NOTICE OF DECISION

Case File: T2-2015-4561

Permit: Significant Environmental Concern for Wildlife Habitat, Hillside Development Permit and Administrative Decision by the Planning Director

Summary: Applicant is proposing to construct a replacement dwelling in the Commercial Forest Use - 2zone. A Significant Environmental Concern permit for wildlife habitat, Hillside Development permit and Forest Development standards review must be approved to replace the dwelling.

SITE PLAN

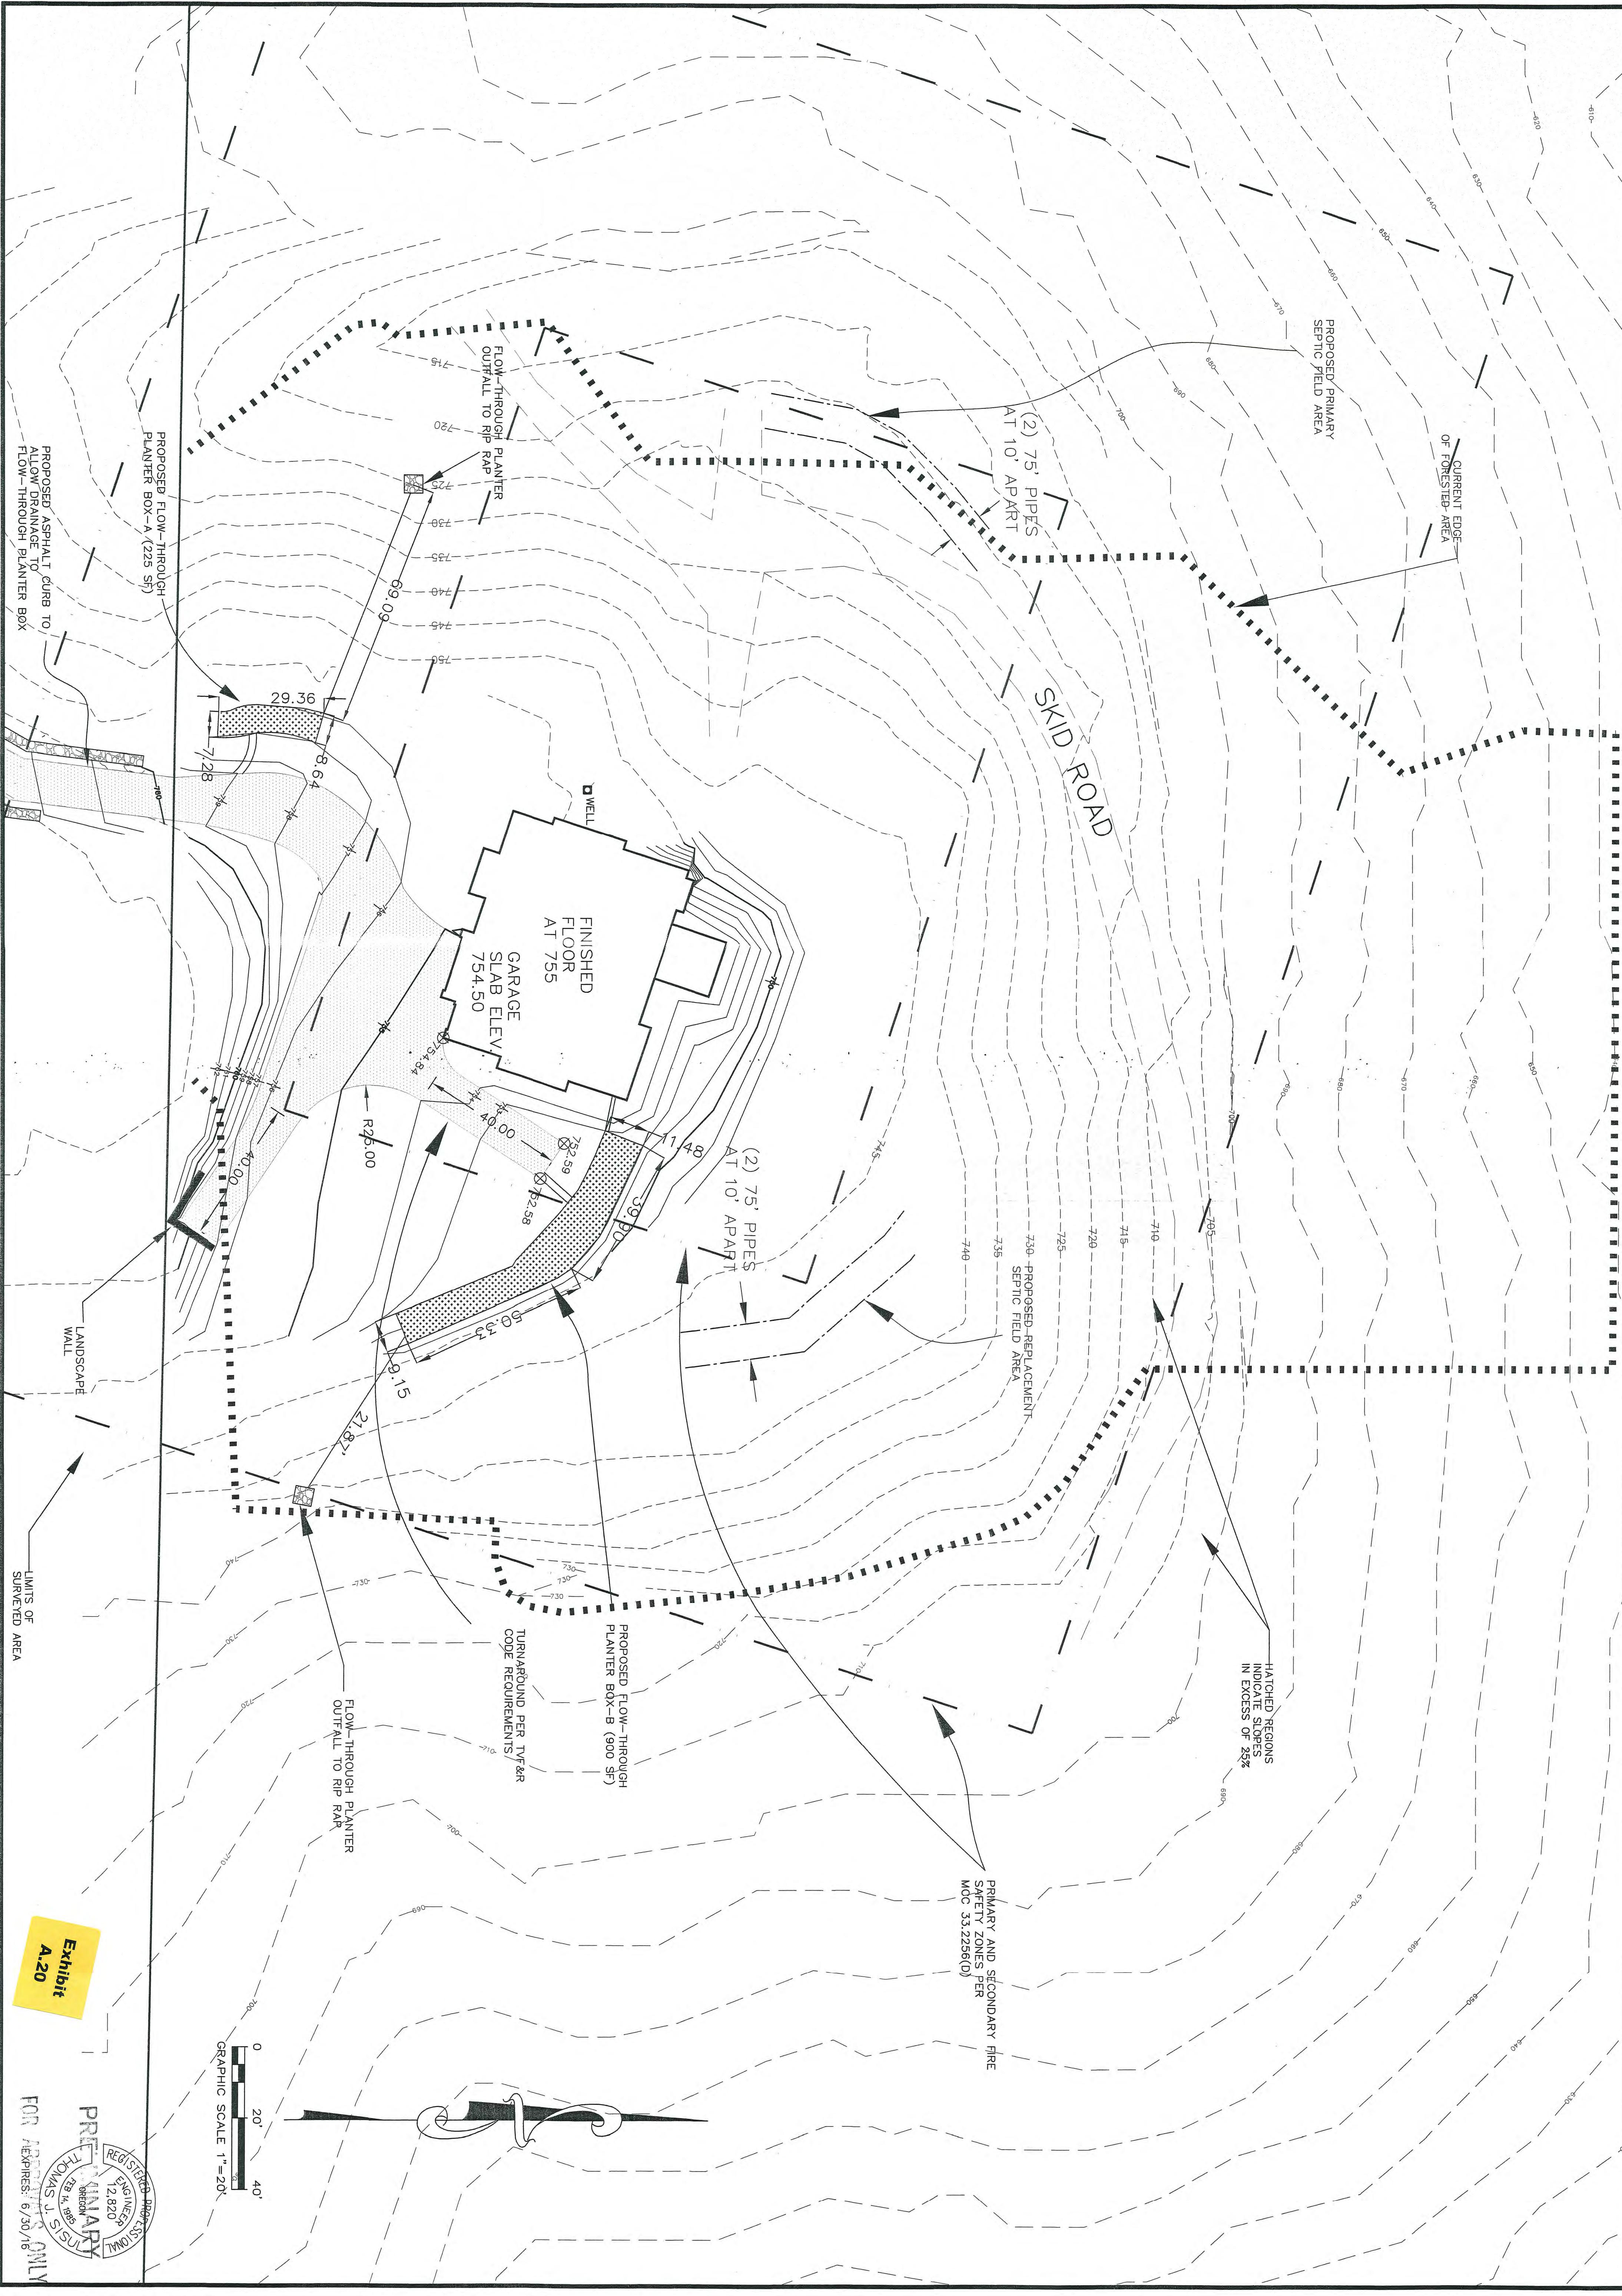
Staff: The applicant's site plan (Exhibit A.19) shows the primary and secondary fire safety zones on it. The primary fire safety zone west of the proposed dwelling has areas with 25%+ slopes (Exhibit A.19 and A.27). The primary fire safety zone will need to be increased on the western side of the new dwelling from 30 feet to 130 feet. The secondary fire safety zone would extend around the primary for another 100 feet. The total primary and secondary fire safety zone between the dwelling and the west property line would be a minimum of 230 feet. The proposed setback from the western side of the dwelling to the west property line is 259.61 feet. As the dwelling is proposed, there is adequate distance to meet the primary and secondary fire safety zone without needing to move the dwelling. The applicant has modified the primary and secondary fire safety zone on the revised site plan (Exhibit A.19). A condition of approval has been included requiring that the vegetation management needed to create and maintain the primary fire safety zone and secondary fire safety zone be added to the plans so that the contractor will know what is necessary to establish these zones. No forestry management plan has been submitted by the applicant so the establishment of the primary and secondary can be accomplished as conditioned. *As conditioned, criteria can be met.*

Staff: The proposed dwelling will be located within 23+/- feet from the existing dwelling's location (Exhibit A.19). The proposed development will need to meet (C). The applicable driveway/road requirements of MCC 33.2261(E) have been removed from the code.

- c. The specifications for the primary and secondary fire safety zones as described in MCC 33.2256(D)(1)(a) and (D)(2) shall be added to the plans to provide instruction on how the vegetation in the primary shall be altered.

- e. The site plan shall be revised to show the location of the existing gate across the driveway and if the gate is to be moved its new location. [MCC 33.4570(C)(3)]

PROPOSED GRADING AND EROSION CONTROL PLAN

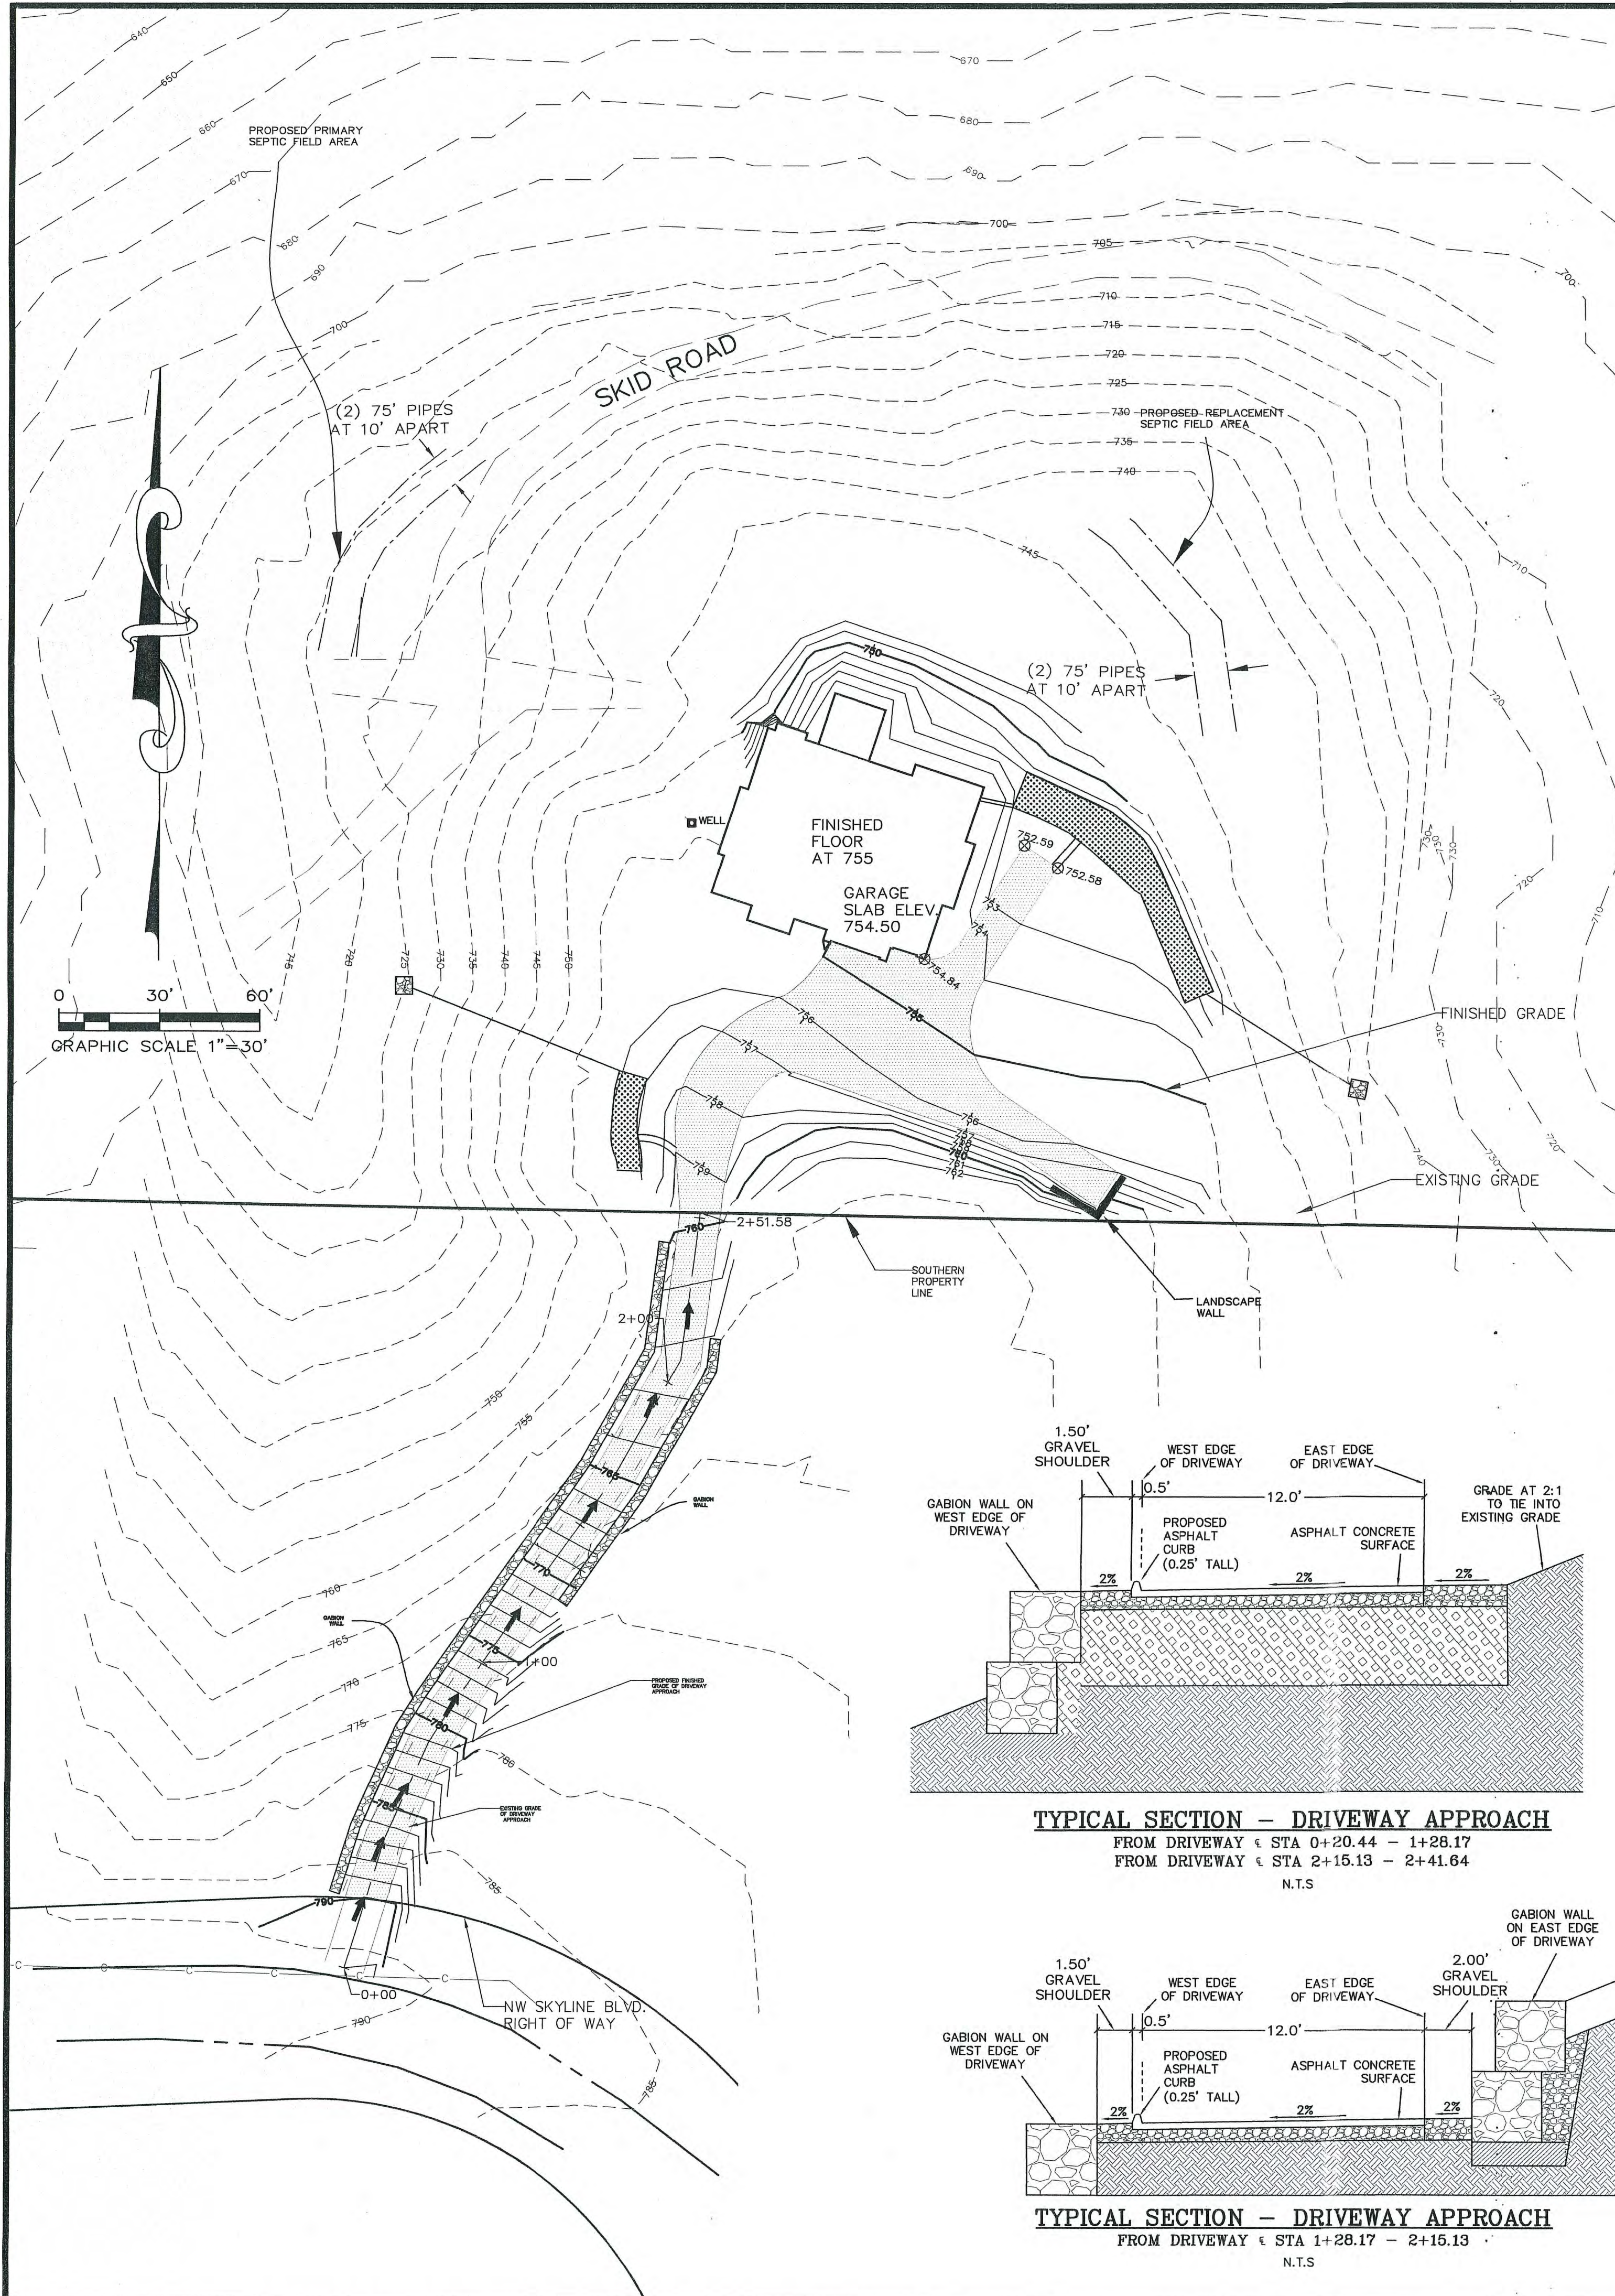
Staff: The applicant indicates that there are no watercourses or wetlands within 200 feet of the proposed disturbance areas of the site. The outfall, riprap and piping for the stormwater planter on the west side of the development appears to be 40 feet from the beginning of a small tributary. The installation of these improvements will involve ground disturbance. A condition of approval has been included requiring that the outfall, riprap and piping remain 100 feet from the tributary or mitigation plantings be added to reduce the potential erosion impacts leading from the outfall to the tributary. *As conditioned, criterion met.*

- f. The erosion control plan shall be revised to include the requirement that all exposed soils be protected with mulch, netting or erosion control blankets unless actively being worked on that day. [MCC 33.5520(A)(2)(b), (d), and (h)].

- g. The outfall, riprap and piping on the western flow-through planter shall be moved to be at least 100 feet from the small watercourse tributary unless a mitigation planting plan is provided by the applicant that reduces the potential erosion impacts leading from the outfall to the tributary. If no mitigation planting plan is provided, all plans shall be revised to show that the outfall is at least 100 feet from the watercourse. [MCC 33.5520(A)(2)(e)]

14. If no mitigation planting plan is provided for the outfall from the western flow-through planter, the outfall shall be installed at least 100 feet from all watercourses on the property. [MCC 33.5520(A)(2)(e)]
